**Request for Information (RFI) Report**  
**KFM Skyway Project # 04-012024**

Subject: KOS RFI #69R1 - Answer to NCR 47 & 48

**TITLE:** Answer to NCR 47 & 48

**PROJECT:** SFOBB Footing Fabrication

NCR # 47 WELD  
LOCATION

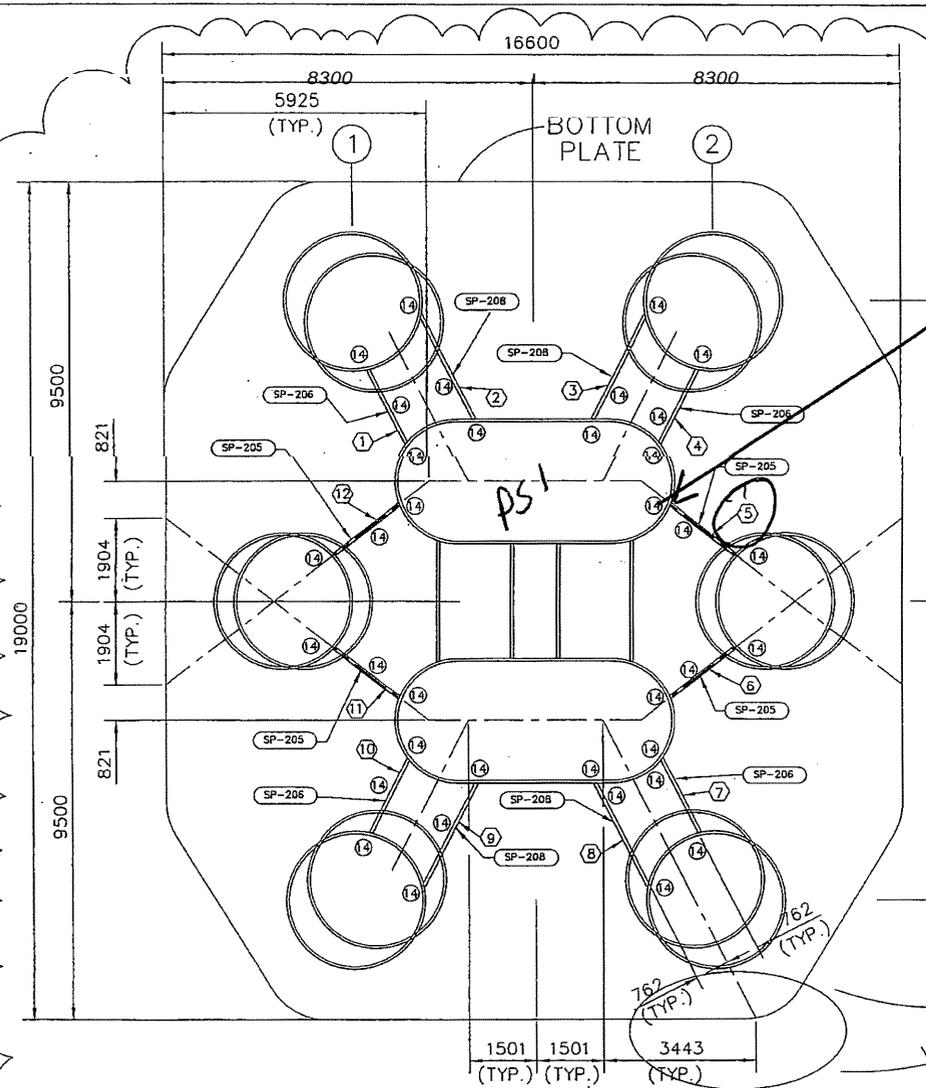
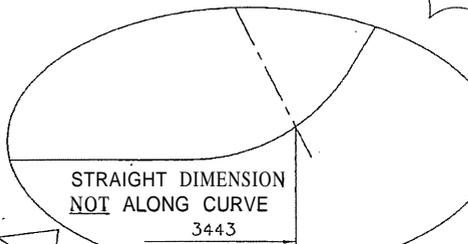
Non-Conformance: Welder stencil TN was observed repairing a weld on SP205 to Pier Socket I near Pile Sleeve B2 on footing E10 East with the pre-heat temperature less than 200 degrees versus the required 275 degrees.

Disposition: The weld pre-heat was brought up to 275 degrees and welding continued on the repair. The repair will be UT and MT tested 100 %. KOS to write an RFI to accept as welded.

We received your Request For Information titled, "KOS RFI #69R1 - Answer to NCR 47 & 48," KFM-RFI-000688 Rev.00 on May 27, 2003. Based upon documentation provided, this RFI is approved. However, please be informed that insufficient preheat is not recommended or acceptable per AWS D1.5, and will not be accepted in the future.

NCR # 48 WELD  
LOCATION

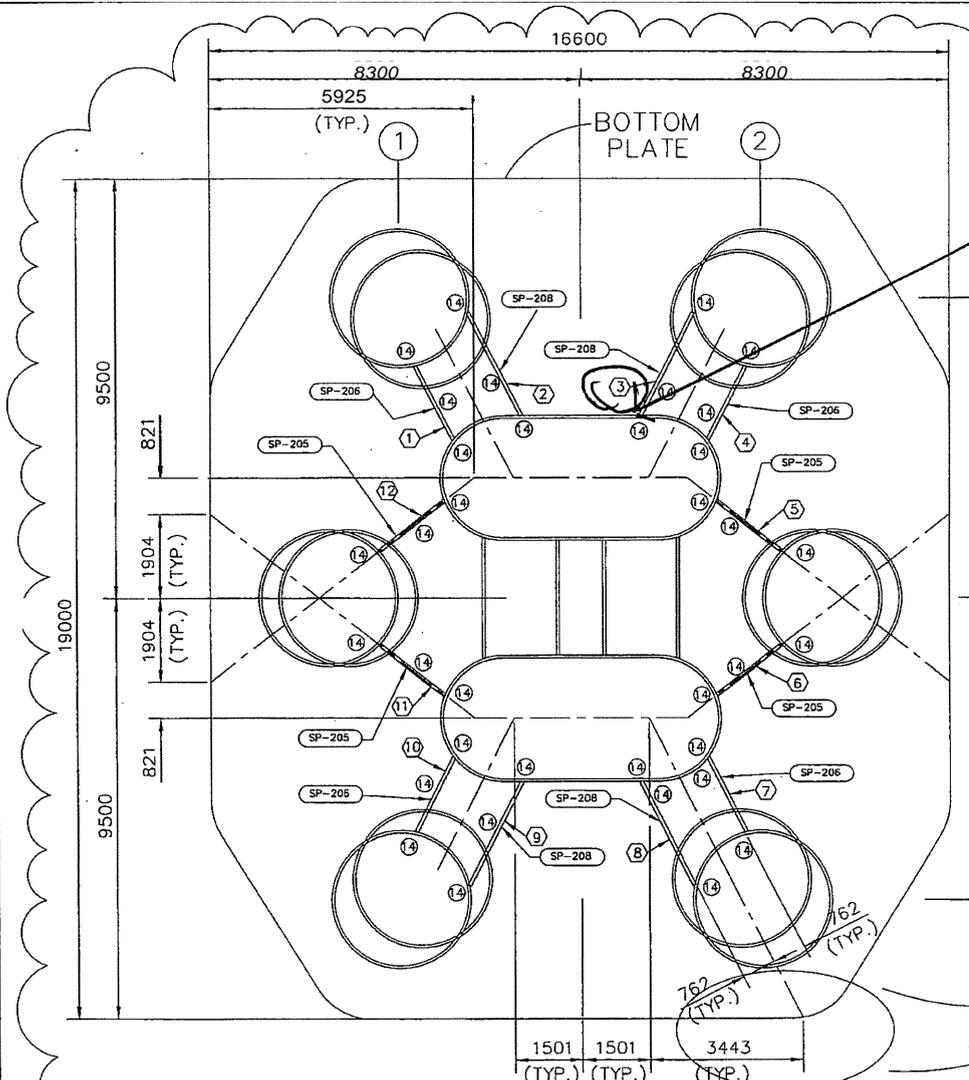
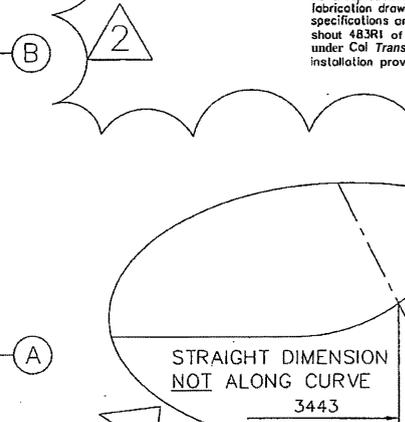
Non-Conformance: Welder stencil DXQ was observed repairing a weld on SP208 to Pier Socket 1 near Pile Sleeve C2. on footina E 10 East with the ore-heat temperature less than 200 degrees versus the required 275 degrees.

Disposition: The weld pre-heat was brought up to 275 degrees and welding continued on the repair. The repair will be UT and MT tested 100 %. KOS to write an RFI to accept as welded.
